# BOURNS®

# Product Update Memo

November, 2006

## Bourns® Trimpot® Division Announces 7914 Product Update

*Brown Housing Material versus New Natural Housing Material*

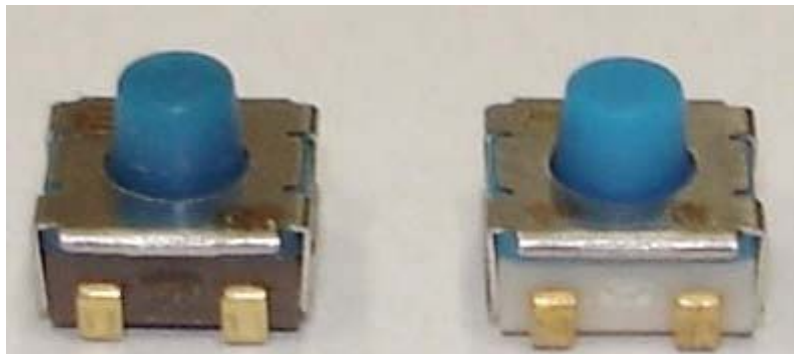
Bourns is pleased to announce a product update to [Model 7914](#). Effective January 1, 2007 with date code 7A, we will begin phasing in a new housing material. The new housing material is natural in color and meets current Bourns recommended processing guidelines.

There is no change in form, fit or function of the product.
